Detailed Site Plan

DSP-20004

Riverfront at West Hyattsville Metro - Parcel 1 ETOD

SUBJECT: Detailed Site Plan for Infrastructure DSP-20004
Type 2 Tree Conservation Plan TCP2-001-2017-01
Riverfront at West Hyattsville Metro - Parcel 1
Expedited Transit-Oriented Development Project

SOUTH ELEVATION

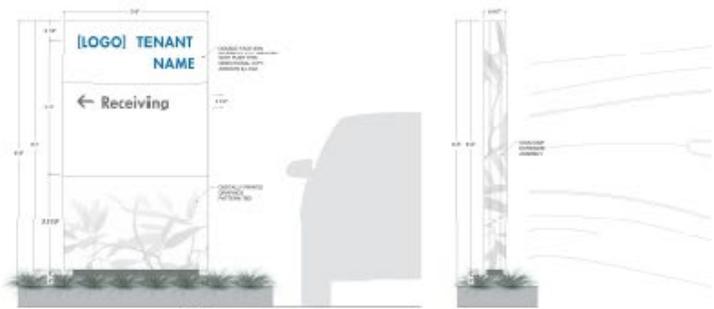
- g. Provide additional outdoor seating for the eating and drinking establishment, along the Ager Road frontage.
 - h. Provide more architectural details or artistic elements to the southern elevation to break up the mass and provide more visual interest.

SIGN B

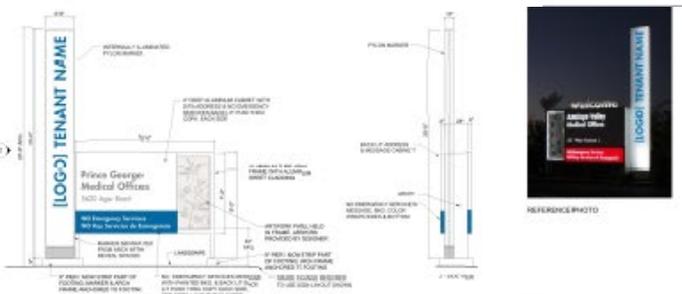
- f. Revise the sign plan to provide a signage schedule detailing all proposed signage, correctly label Sign B, label the width of all signs, and provide details and dimensions of the LED façade logo/graphic within the east elevation.
